Proposal for amendments to Regulation No. 60 (Two-wheeled motorcycles and mopeds - identification of controls, tell-tales and indicators)

The text reproduced below was prepared by the expert from IMMA to amend the requirements for identification of controls, tell-tales and indicators on two-wheeled motorcycles and mopeds. It is based on GRSG-108-47 and takes into account the suggestions made during the 108th GRSG meeting.

Some examples of small irregularities that are found on actual vehicles:

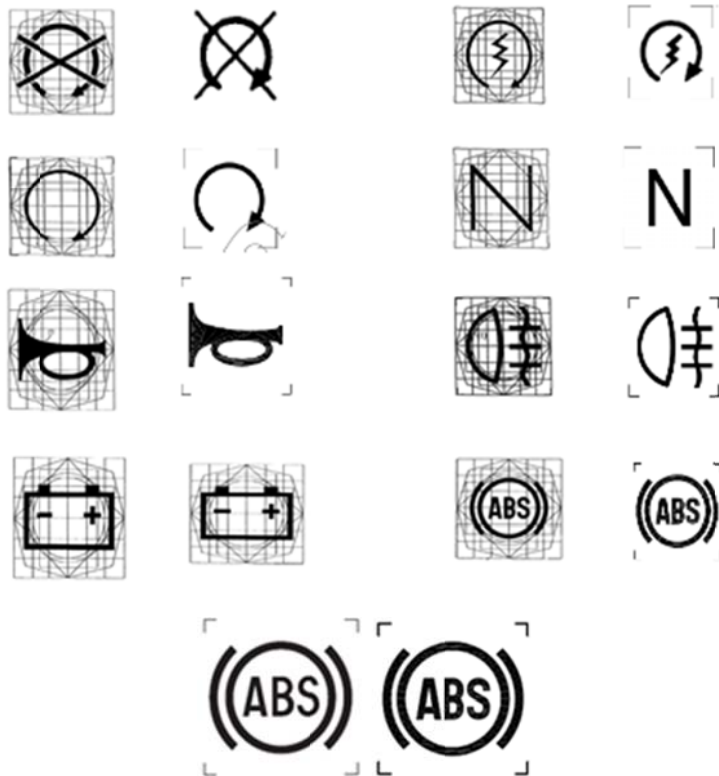
3. Reproduction of the Regulation itself and constraints in production processes can lead to small differences in appearance of the symbol on actual vehicles. Such irregularities do however not endanger the correct understanding of the symbol and should therefore not lead to interpretation differences at the time of type approval.

"5.3.1.1. It shall be ensured that no substantial deviations in the shape and orientation of the provided symbols are permitted, notably that any customised appearance of the provided symbols shall be prohibited.

5.3.1.2 Small irregularities concerning line thickness, the marking application and other relevant tolerances shall be accepted, as provided in paragraph 4 of ISO 2575:2010/amd1:2011 (design principles)."
